Docket Item # 1 & 2
BAR CASE #2013-0013/0014

BAR Meeting
February 20, 2013

ISSUE: Permit to Demolish/Capsulate and Certificate of Appropriateness
APPLICANT: Fred Brewer by Christine Kelly, AIA
LOCATION: 416 N Union Street
ZONE: RM / Residential

BAR2013-0013 & BAR2013-0014

DEPARTMENT OF PLANNING AND ZONING FLOOR AREA RATIO AND OPEN SPACE CALCULATIONS

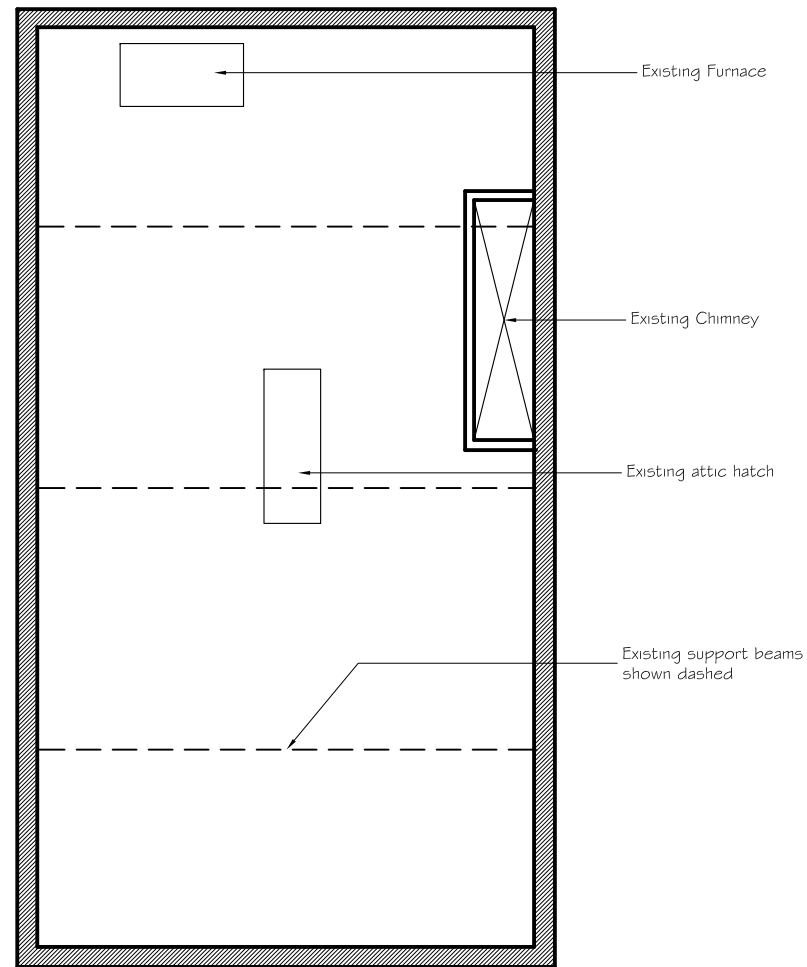
C-2 The applicant will need to submit floor plans showing the areas to be excluded from FAR.

Proposed Floor Plan
Proposed East Elevation

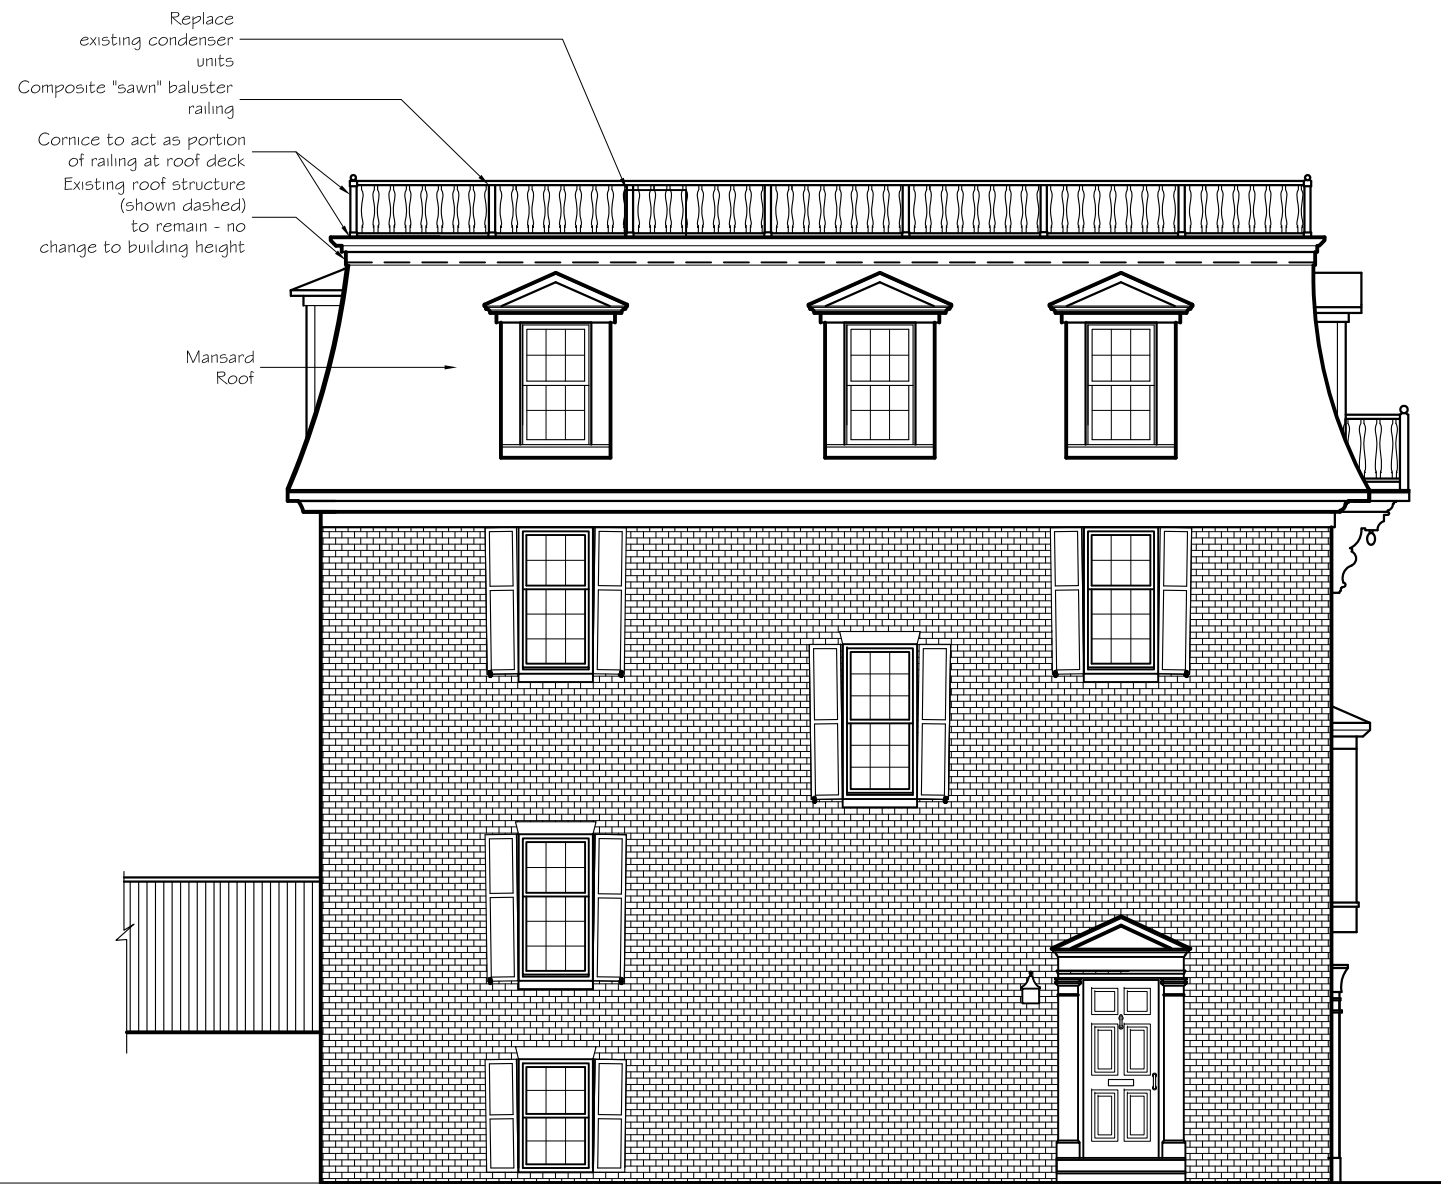
Staff notes that the cornice along the top edge of the parapet abutting the adjacent neighbor appears to extend beyond the property line. Staff recommends that the architect verify that it does not extend beyond the property line or obtain an easement from the neighbor (which Staff recommends) prior to submission of construction permit drawings. Finally, it is recommended that the construction drawings include design details for the cornice and parapet for final review by Staff to insure that they are compatible with the proposed new architectural style.

The *Design Guidelines* state that “dormers should align with the existing windows or be centered between the windows.” Historically, “dormers are generally tall and narrow with minimal trim at the sides of the windows.” The applicant is proposing to add pedimented dormers to the front, side and rear elevations clad in HardiePlank siding with a five inch reveal and sheathed in metal or faux slate. Based on the elevation drawings, the dormers appear to have slightly different detailing on each elevation. Therefore, it is recommended that the architect work with staff to refine the dormer’s detailing prior to the submission of construction permits.

1. That the final design details for the dormers, cornice, parapet, roof and balcony balustrade, and the brackets be approved by Staff;
2. That all proposed materials be in conformance with BAR policies and be reviewed and approved by BAR staff prior to submission of construction permit drawings.

6. That the muntin width of the new windows match the existing windows 5/8" muntin.
7. That the cornice along the top edge of the parapet abutting the adjacent neighbor may not extend beyond the property line unless the applicant obtains an easement prior to submission of construction permit drawings.

Proposed Exterior
Elevations

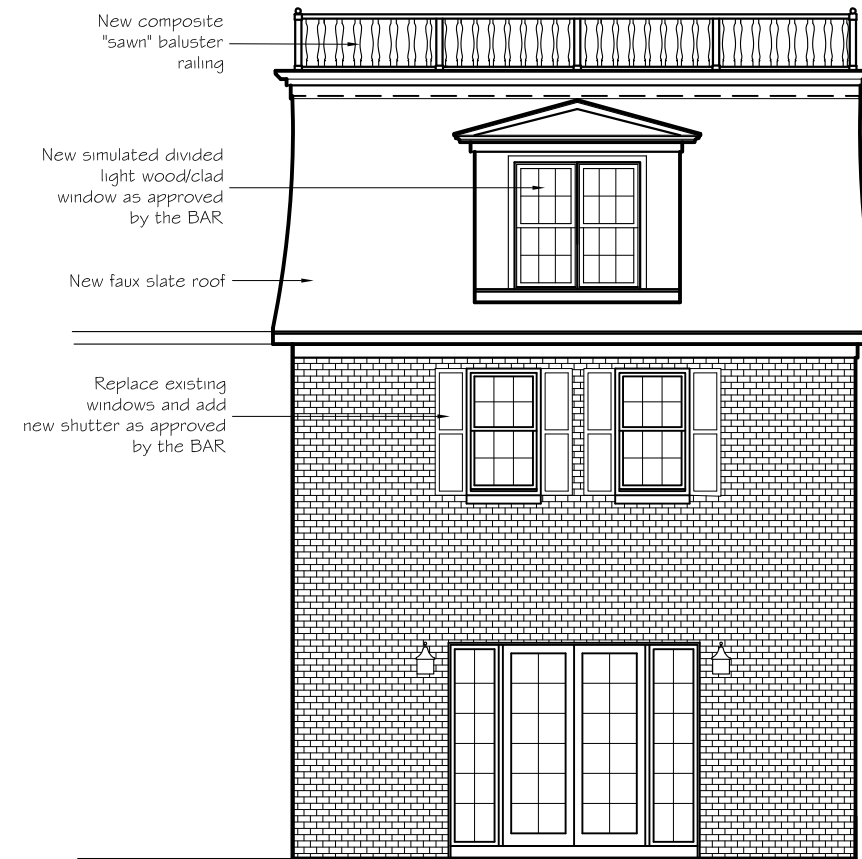
The *Design Guidelines* and the Board’s *Window Policy* support the use of a aluminum-clad wood, simulated divided light windows on buildings constructed after 1969, however in this situation, since all the windows are not being replaced, it is recommended that the muntin width of the new windows match the existing windows 5/8” muntin width. In addition, since the house is being converted into a Neo-Victorian, it is the strong preference of the Board, that architectural elements of a particular style not be mixed and matched on modern or historic buildings within the district, therefore, it is recommended that when the owners elect to replace the existing windows on the house in the future, that the windows be replaced with a 2/2 window configuration - a more compatible window treatment for the Second Empire style.

3. That the faux slate will be installed with two shades of the same color and randomly mixed;
4. That all new simulated divided-light, aluminum-clad wood windows comply with the BAR's Window Policy.
